CONSTRUCTION PLANS FOR:

**OWL MARKETPLACE**  
 EL PASO COUNTY, COLORADO

**GENERAL NOTES & ROAD CROSS SECTIONS**

**Know what's below. Call before you dig.**  
 CALL 2-BUSINESS DAYS IN ADVANCE BEFORE YOU DIG, GRADE, OR EXCAVATE FOR THE MARKING OF UNDERGROUND MEMBER UTILITIES.  
 PCD FILE: VR2321

**STORM SEWER PLAN & PROFILE WEST MPD**

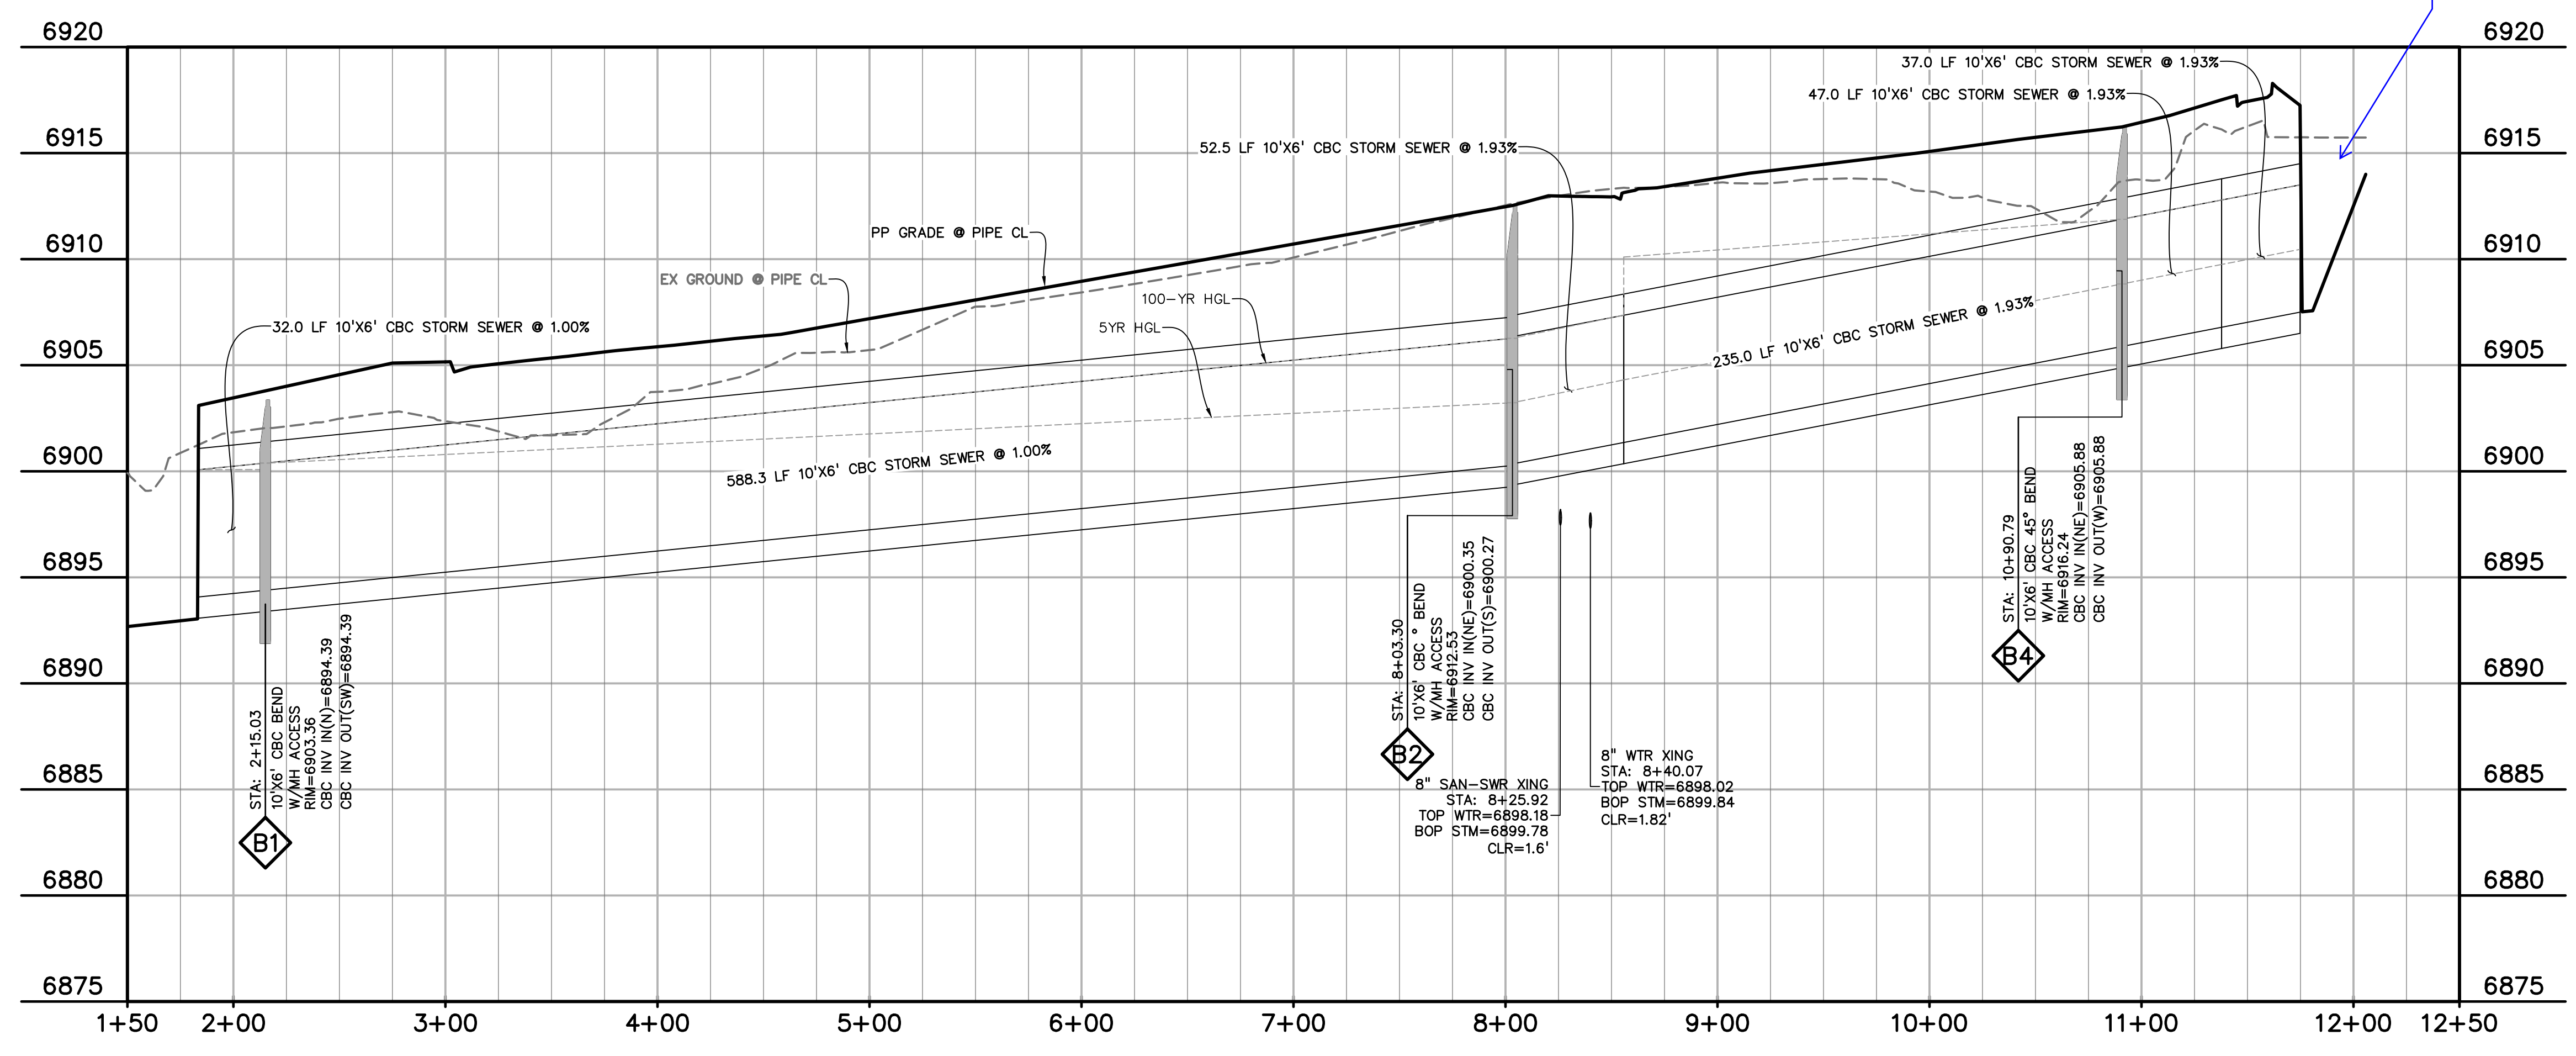
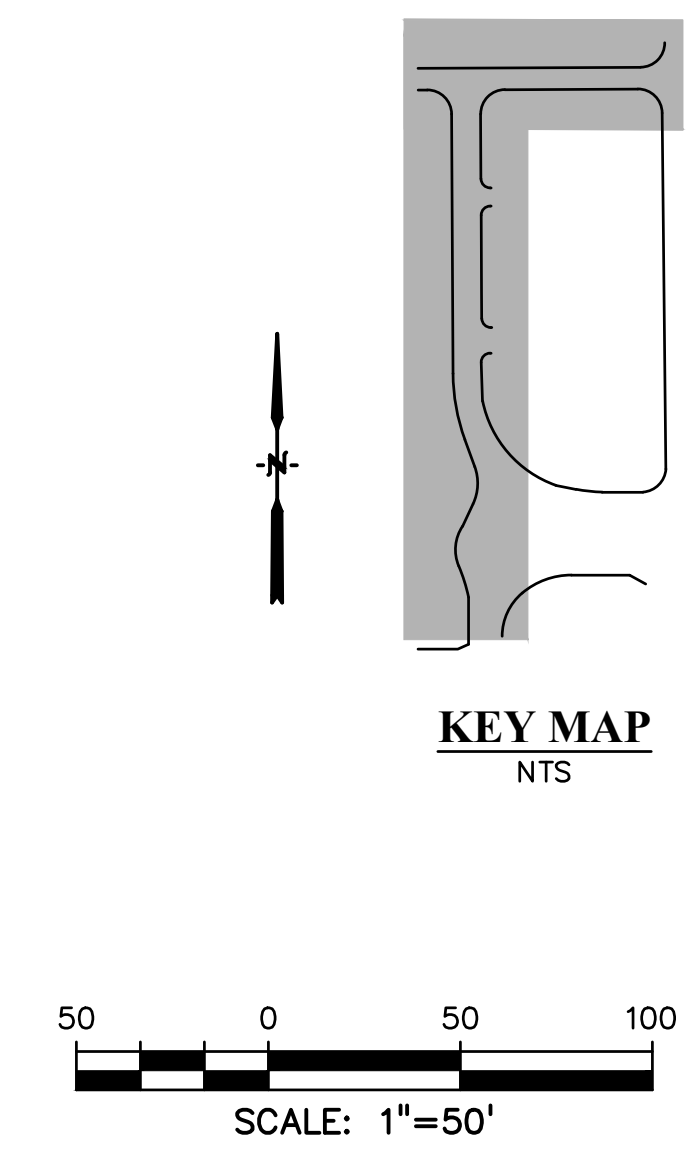
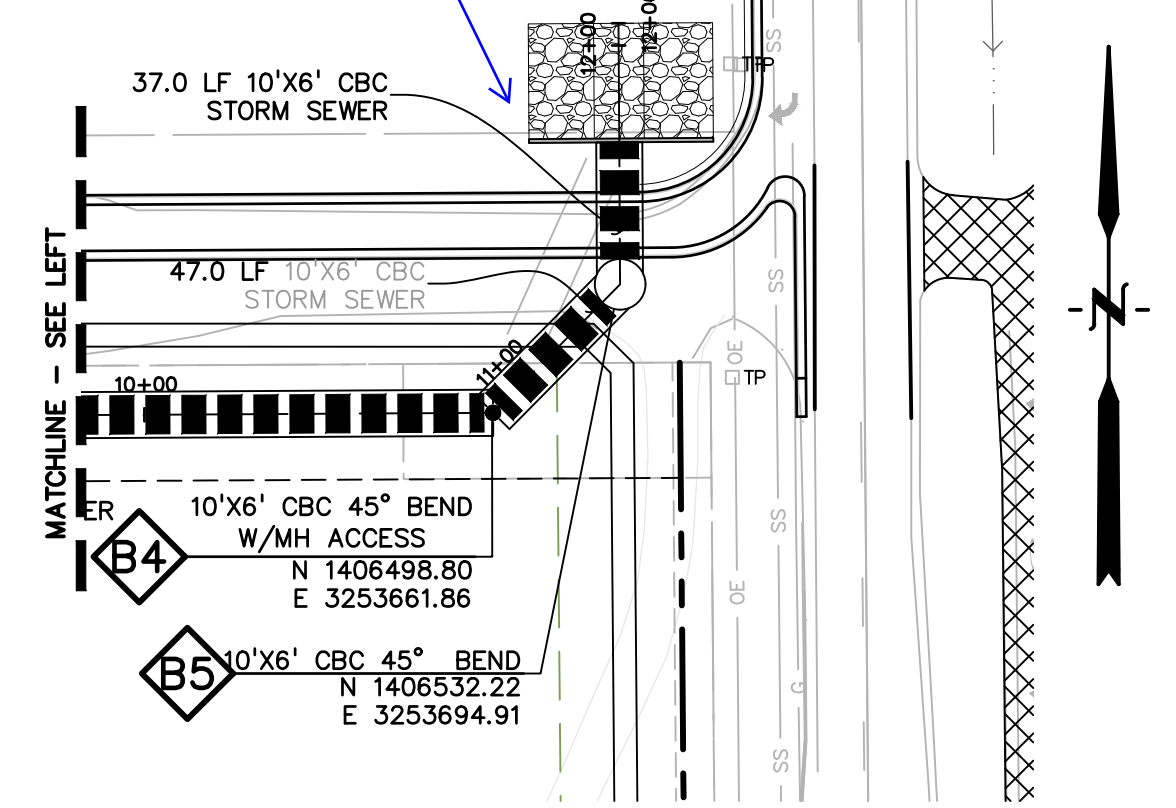
review 1: show headwater depth  
 Review 2: unresolved.
